# CITY PLANNING COMMISSION

- APPLICATION:**
- A. Negative Declaration
  - B. Variance to locate the required four foot planter in the public right-of-way
  - C. Variance to increase the maximum 30 percent compact car allowance to 40 percent
  - D. Variance to waive the required six foot high masonry wall along the north property line

**LOCATION:** Northwest corner 18th Street and Capitol Avenue

**PROPOSAL:** The applicant is requesting the necessary entitlements to develop an on-site parking lot for a future 2,000 square foot office.

# STAFF EXHIBIT A

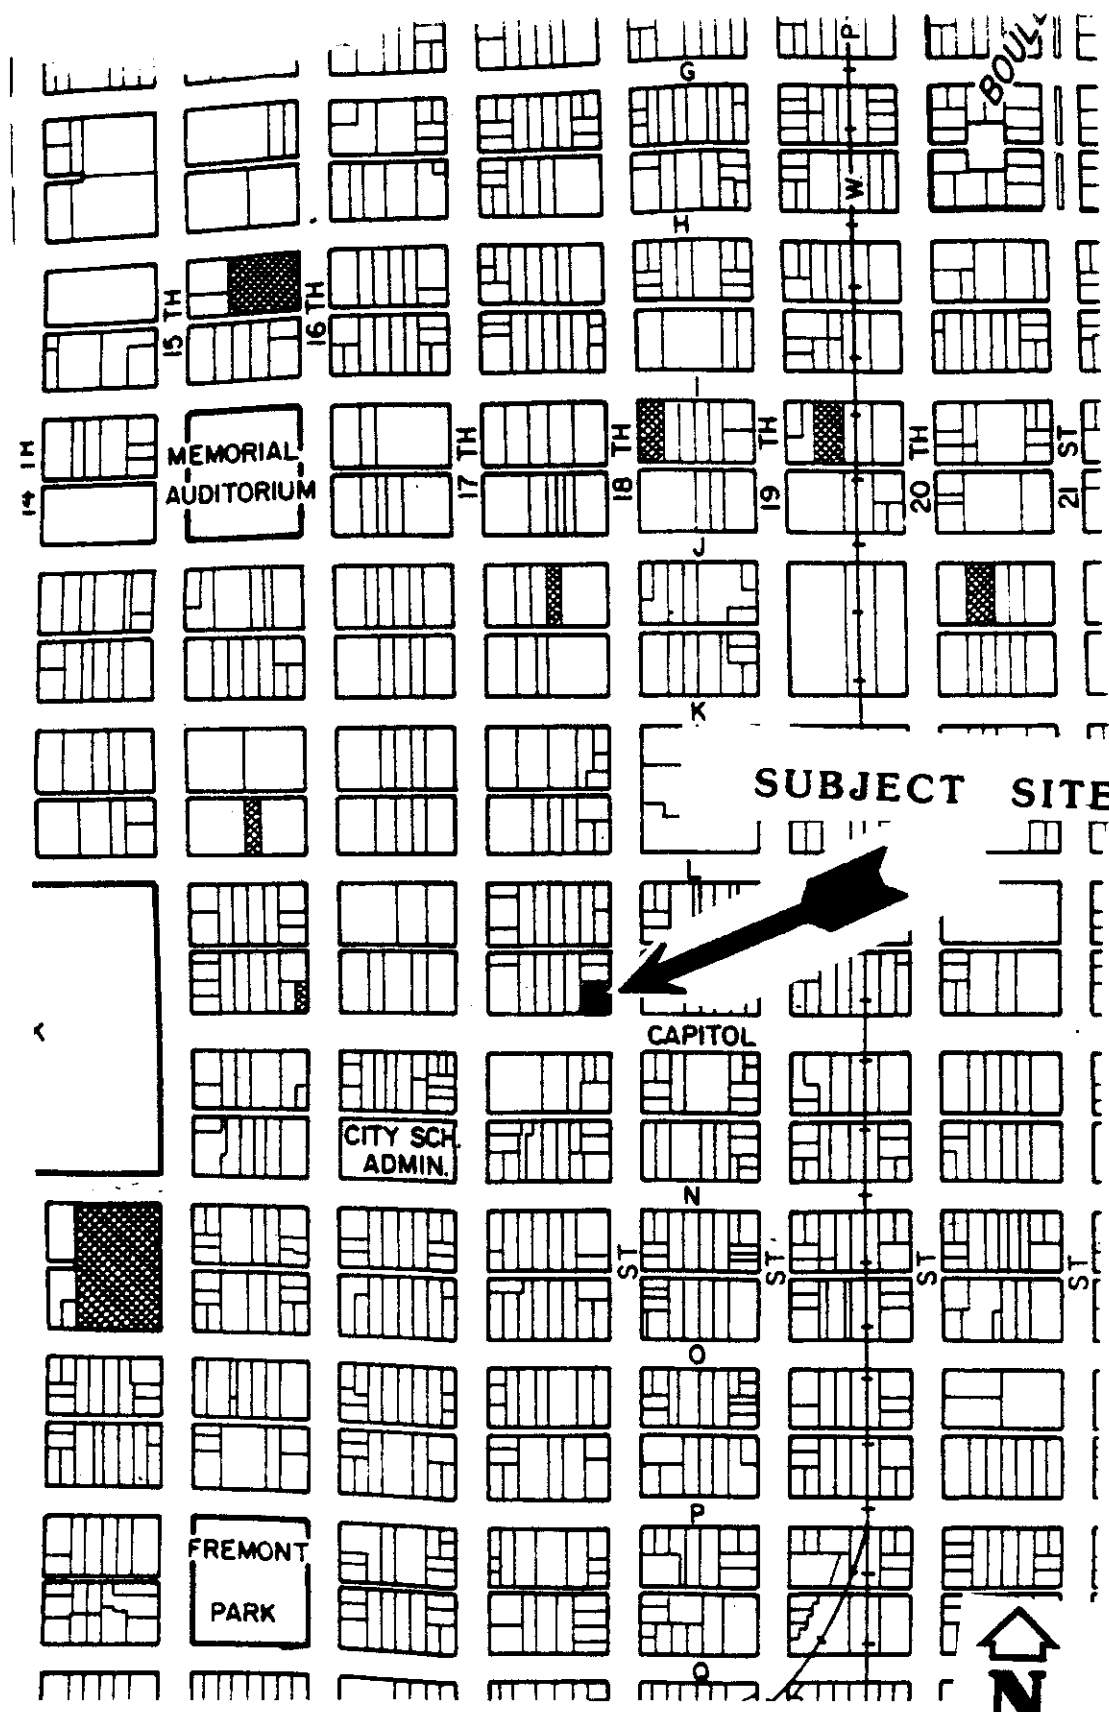
1. Building Addition: Staff's recommendation is to place the proposed office building so that a five foot setback is provided along the north property line. See staff Exhibit A. This would allow the existing apartment to the north to have more light and air rather than placing a 29 foot high parapet wall on the north property line as proposed. Staff notes the existing apartment building wall is located four feet + from the property line. This would necessitate redesigning the proposed office to provide a second story overhang over the parking stalls. The other alternative is that the entire ground floor of the building could be placed where the proposed parking stalls 6-9 are located. Eliminating these parking stalls would still leave the applicant with the five required parking spaces near the Capitol Avenue frontage.

2. Parking Design: The compact parking space located near the main entrance should be redesigned. This proposed parking stall does not provide adequate backout and maneuvering area. This should be a minimum 10 foot wide stall. Staff feels the proposed parking lot can be redesigned to accommodate the required landscaped planters on-site (see staff Exhibit A). Placing the required landscape planters on-site will eliminate car bumpers overhanging into the public right-of-way along Capitol Avenue and thus improve the landscape along Capitol Avenue. In addition, the compact parking spaces should remain 30 percent as required by ordinance. No hardship exists to warrant an increase to 40 percent.

Staff notes the applicant proposes standard parking stall depths of 16 feet and compact parking stall depths of 14 feet. The Zoning Ordinance requires a standard stall depth of 18 feet and a compact parking stall depth of 16 feet, unless a six foot wide planter is proposed. Therefore, the proposed parking stall depths located beneath the proposed office building overhang must be increased to 18 feet.

In conclusion, staff recommends all required landscape planters be located on-site. A six foot wide planter should be installed along Capitol Avenue to allow a two foot bumper overhang. The five foot building setback area along the north shall be landscaped with five gallon trees and shrubs sufficient to provide some landscape screening of the proposed building wall.
